CONSULTEK

Project #126: Motor Tolerance Analyses

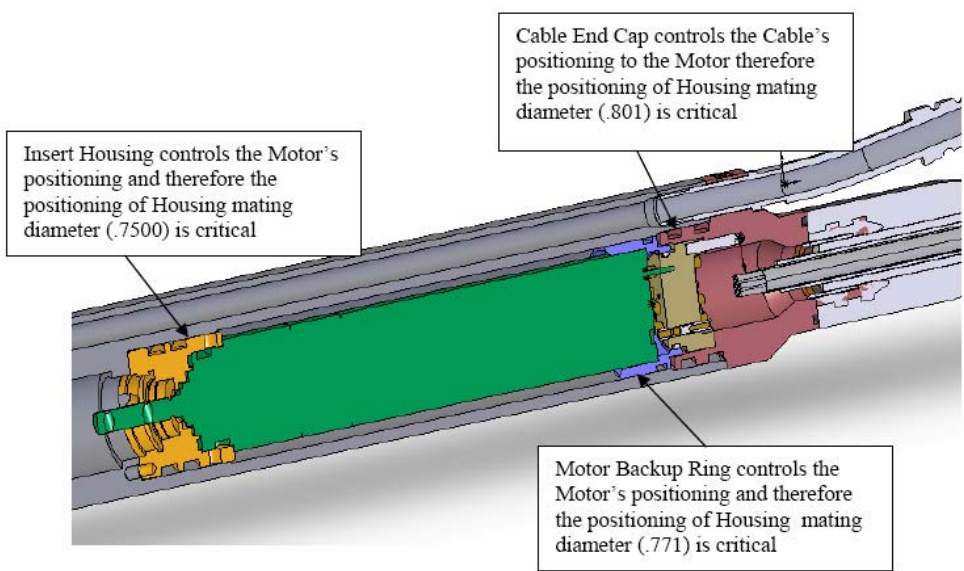
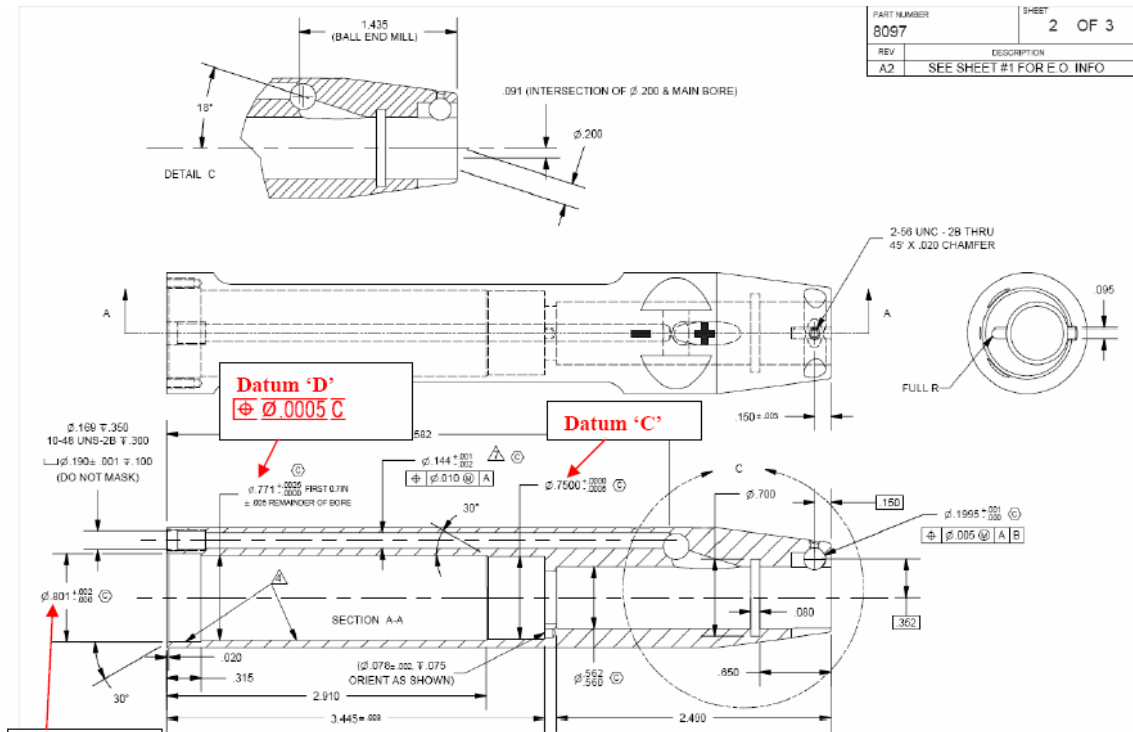
1. The analysis showed a **.0067** interference between the Motor and the Motor Backup Ring
2. The actual positioning of the pins to the cables could not be analyzed because the Motor Connector drawing was not provided.
3. The distance between center lines of the Motor and the cavity that houses the cables (Motor Connector) is **.007** at worst-case conditions.

PART NUMBER	SHEET
8097	2 OF 3
REV	DESCRIPTION
A2	SEE SHEET #1 FOR E.O. INFO

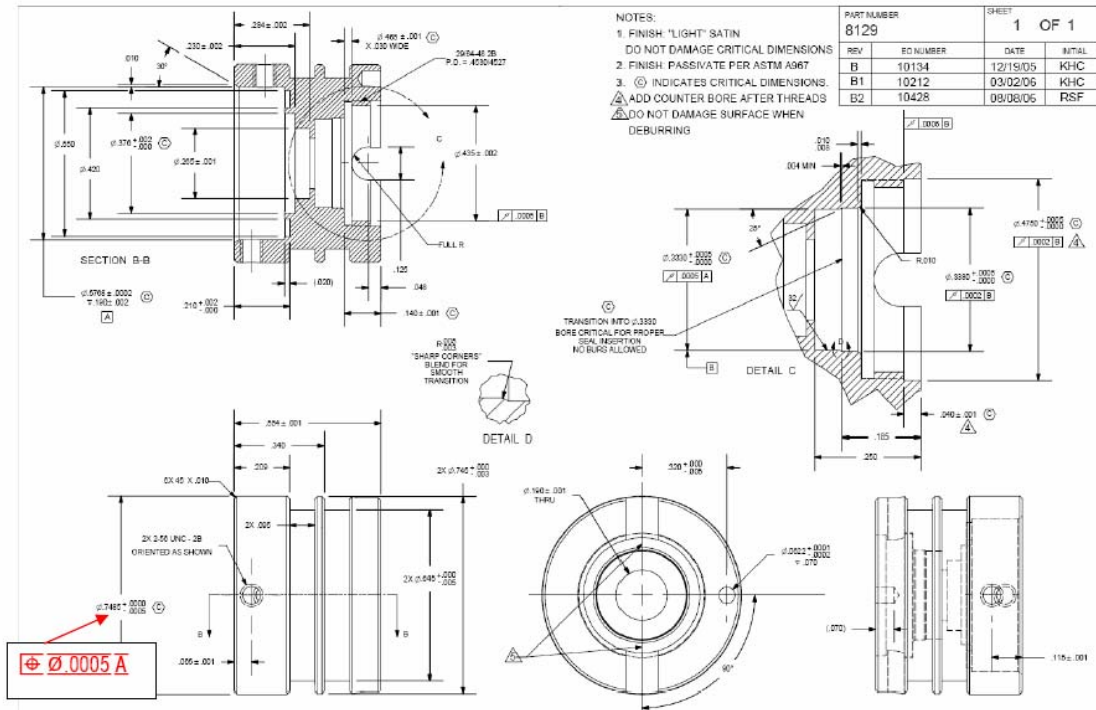
4. Outlined below are the recommended changes for the key diameters of the different related components within the Arthrex assembly.
 - a. **Housing (P/N 8097):** The holes that meet with the Insert Housing and the Motor Backup Ring need to be controlled to ensure proper alignment of the Motor to the Cable. The proposed changes are as follows,
 - i. Make the .7500 diameter datum 'C'
 - ii. Add a true-position callout on the .771 diameter to datum 'C'
 - iii. Add a true-position callout between the Motor Backup Ring mating diameter and the Cable End Cap mating diameter

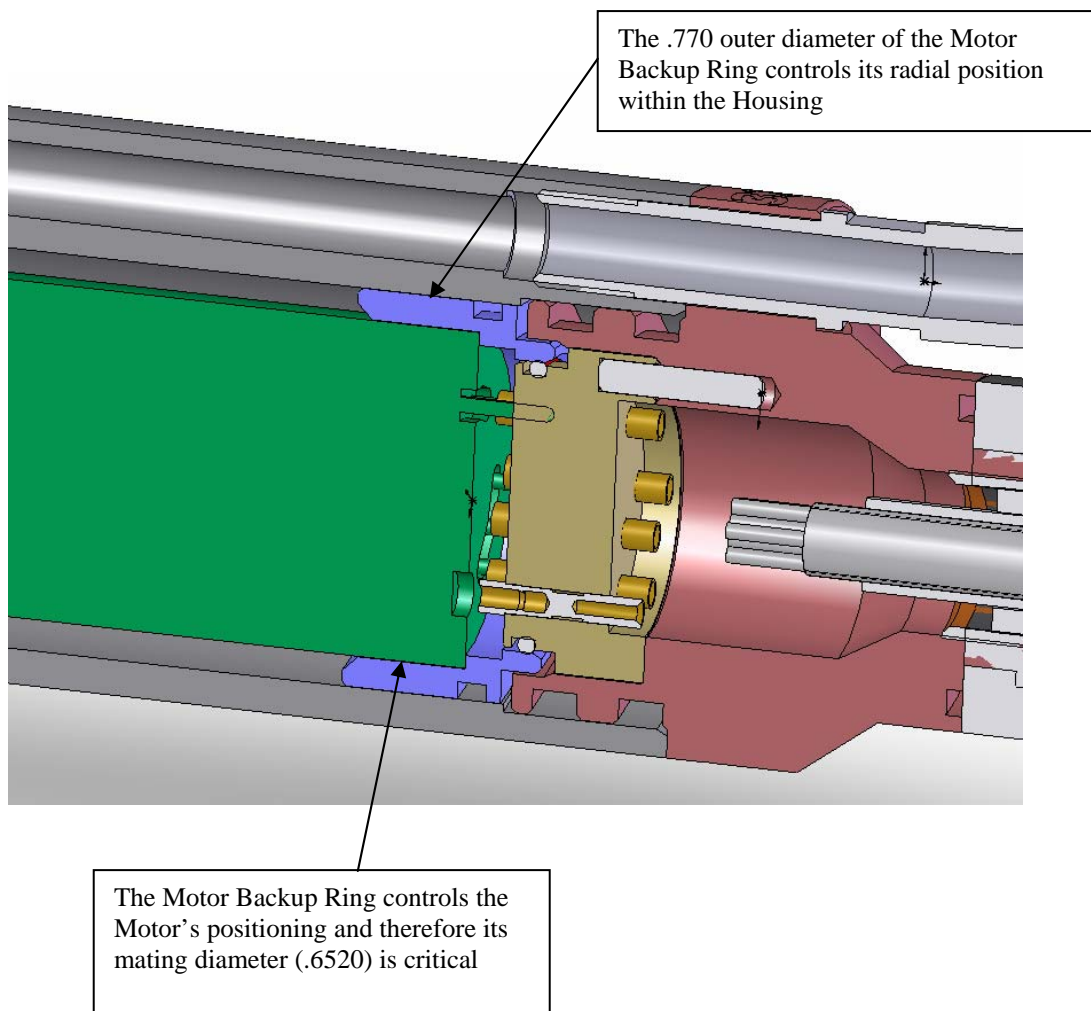
b. **Insert Housing (P/N 8129):** The outer diameter of the Insert Housing needs to be controlled to the mating diameter of the Motor to ensure proper alignment of the Motor to the Cable. The proposed change is as follows,

iv. Add a true-position callout on the .7485 diameter to datum 'A'

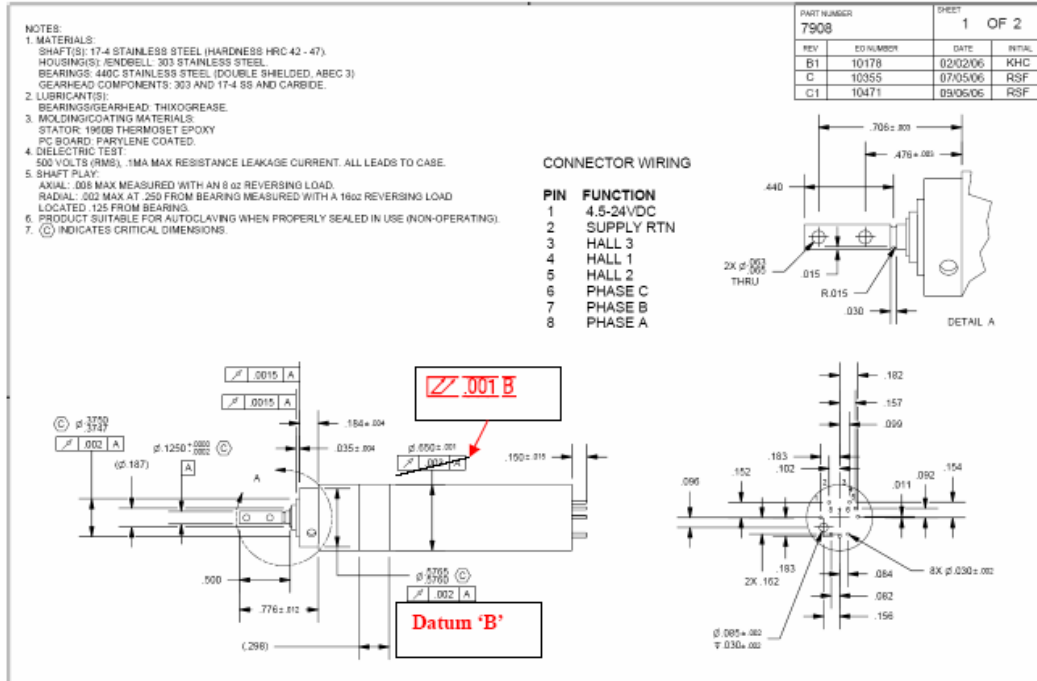
d. **Motor (P/N 7908):** The outer diameter of the Motor needs to be controlled to the diameter that meets with the Insert Housing to ensure that the Motor is properly positioned to the Cable. The proposed changes are as follows,

vii. Add datum 'B' to the mating diameter of the Insert Housing (.5765/.5760)

viii. Add a total runout specification on the .650 diameter to datum 'B'

PART NUMBER		SHEET	
8060		1 OF 1	
REV	SO NUMBER	DATE	INITIAL
A	10006	09/27/05	KHC
B	10053	11/01/05	KHC

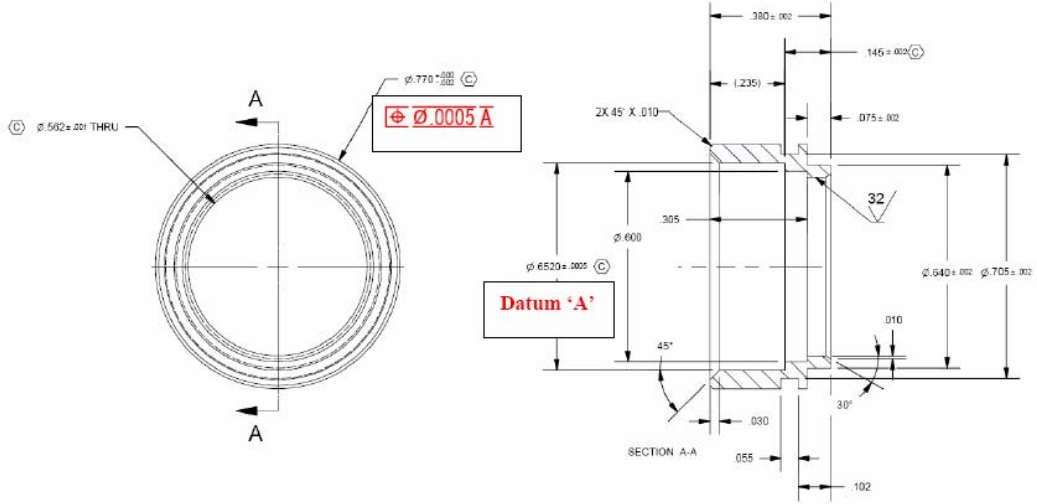
- c. **Motor Backup Ring (P/N 8060):** The outer diameter of the Motor Backup Ring needs to be controlled to the mating diameter of the Motor to ensure proper alignment of the Motor to the Cable. The proposed changes are as follows,
- v. Add datum 'A' to the mating diameter of the Motor (.6520)
 - vi. Add a true-position callout on the .770 diameter to datum 'A'

5. **Analysis after implementing recommended positional callouts:**

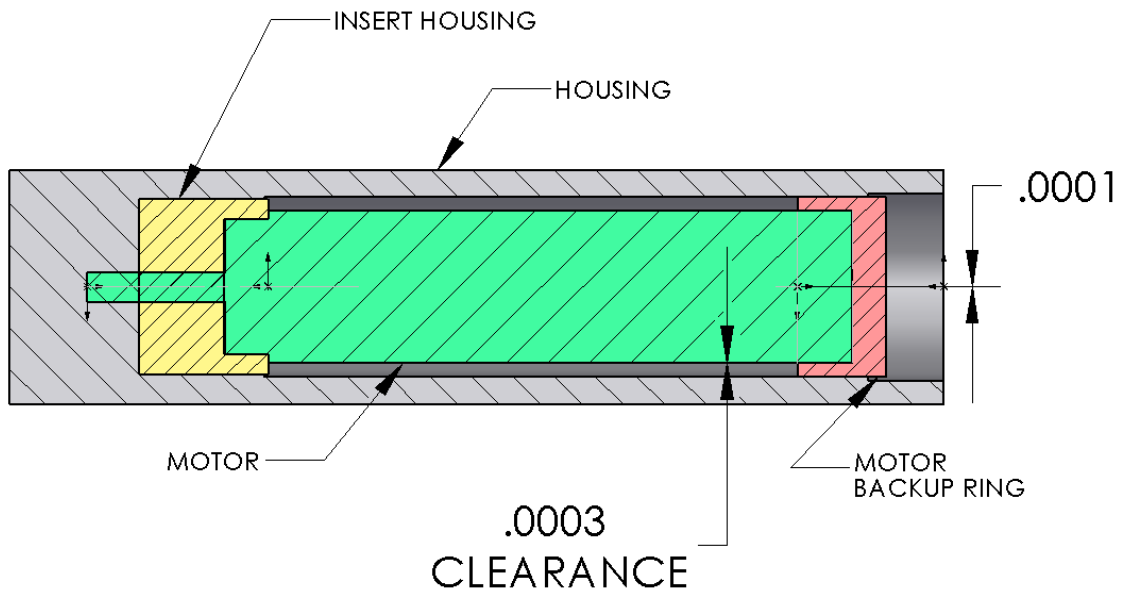
- a. The .0067 interference between the Motor and the Motor Backup Ring was eliminated creating a .0003 clearance.
- b. The distance between center lines of the Motor and the cavity that houses the cables (Motor Connector) was greatly improved from .007 to **.0001**.
